Landscape Referral Response

Application Number:	DA2019/1190
Date:	22/05/2020
Responsible Officer:	Daniel Milliken
Land to be developed (Address):	Lot 1 DP 651395 , 9999 Pittwater Road BROOKVALE NSW 2100 Lot 1 DP 784268 , 9999 Pittwater Road BROOKVALE NSW 2100 Lot B DP 966128 , 9999 Pittwater Road BROOKVALE NSW 2100 Lot 6 DP 785409 , 9999 Pittwater Road BROOKVALE NSW 2100

Fig. 1 TPZ & SRZ overlay

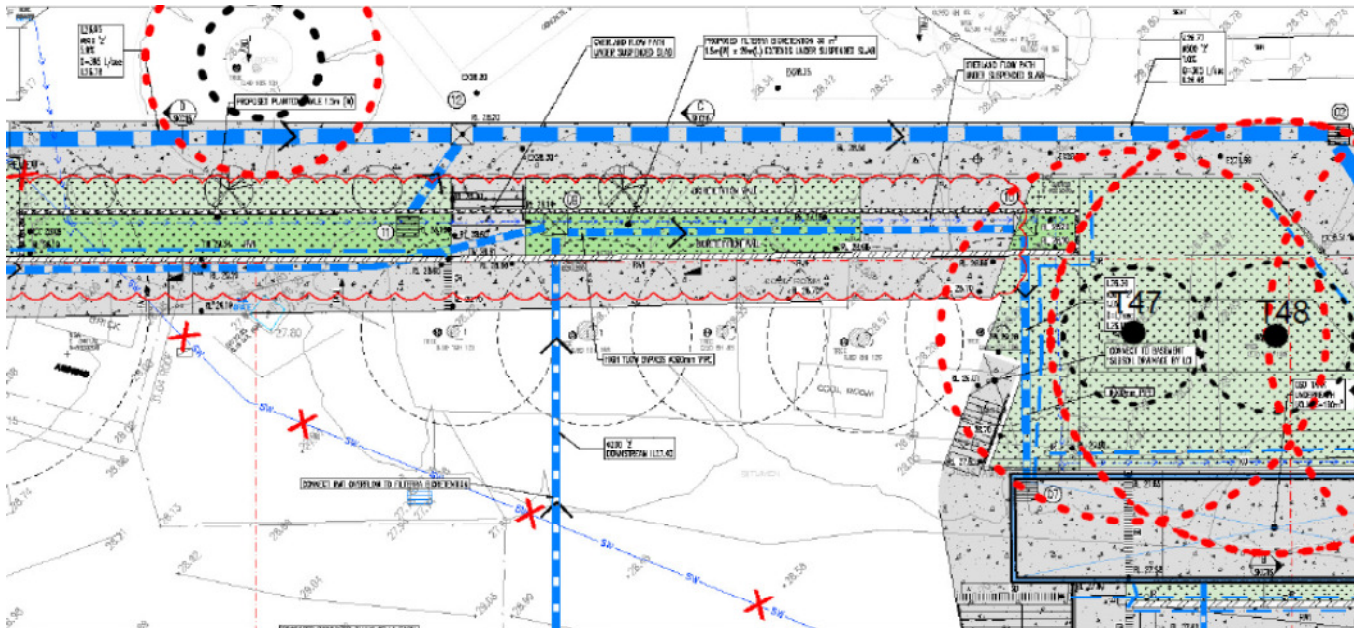
Concern is raised with regard to the impacts on trees proposed for retention adjacent to the stormwater works shown on the Storm Water and Site Works Concept Plan Dwg No. C05-2 A prepared by TTW.

Review of the proposed works in accordance with AS4970-2009 *Protection of trees on development sites* indicates significant impacts on Trees T47, T48 and T49 which would render them unsuitable for retention. Fig. 1 below indicates the Tree Protection Zone (Red dash circle) and Structural Root Zone (Black dash circle) overlaid on to the stormwater drawing.

Based on the TPZ of each tree as identified in the applicant's Arborist report, the following impacts have been calculated.

T47: TPZ radius 7.9m; TPZ area 196m²; Works incursion 74m² = **38% of TPZ**

T48: TPZ radius 9.2m; TPZ area 266m²; Works incursion 125m² = **47% of TPZ**

T49: TPZ radius 10.9m; TPZ area 373m²; Works incursion 74m² = **37% of TPZ**

These impacts are considered too great to enable retention of trees T47, 48 and 49.

Fig. 2 Swept path drawing

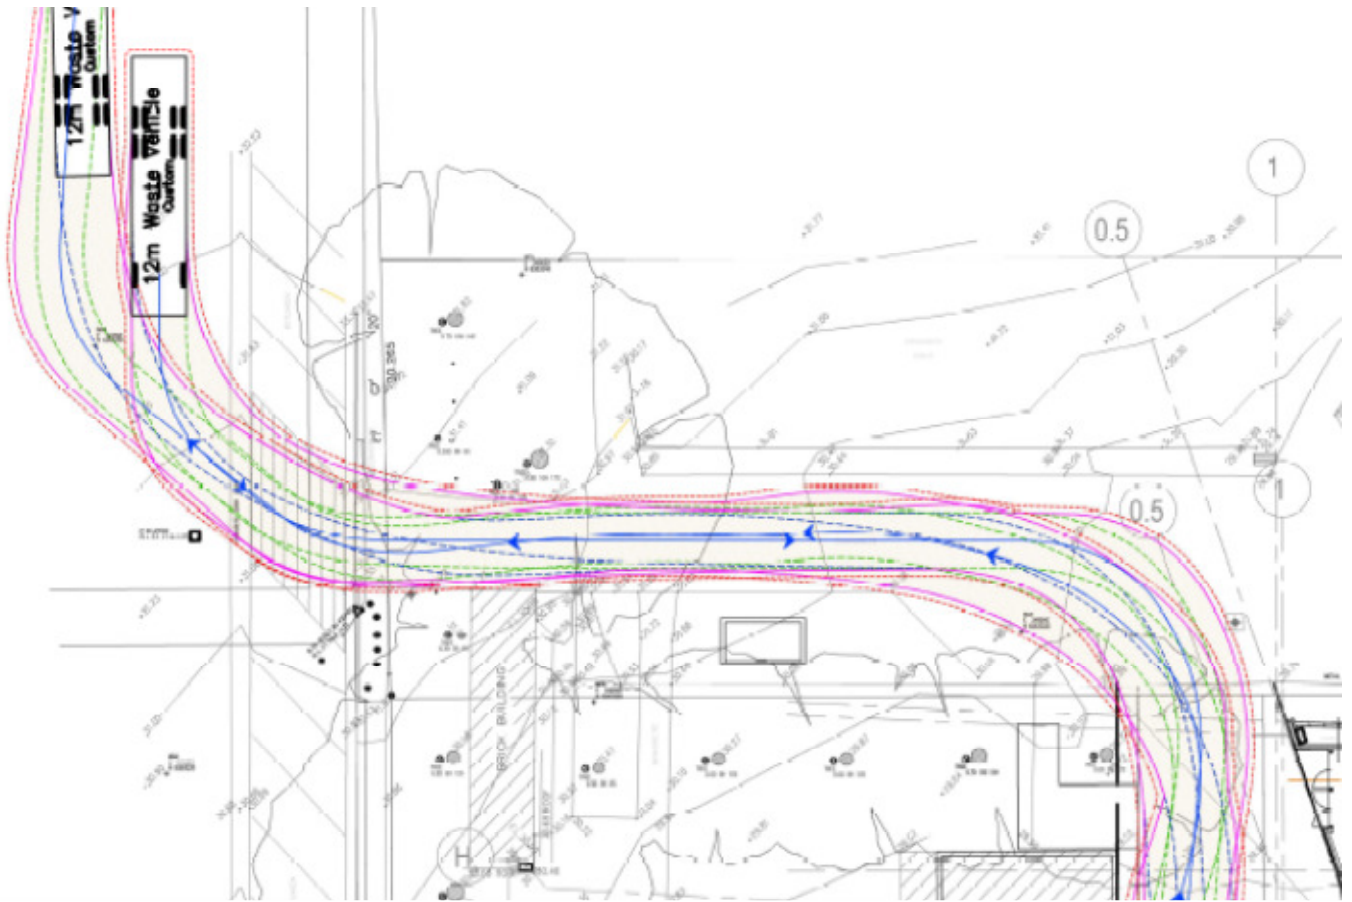
A drawing has been provided indicating the swept path for waste service truck to access the site (Fig 2 below). Several trees (including one heritage listed tree) are close to the routes indicated and it is unclear if additional hard paving areas are required to accommodate the trucks. It is likely that additional pruning would be required and there is potential for ongoing trunk damage given the close proximity of the tracked path to the tree trunks. The existing entry arrangement is indicated on Photo 1 below. This may be able to be addressed through further information, however the plan again highlights the ongoing impact of the development on the existing trees.
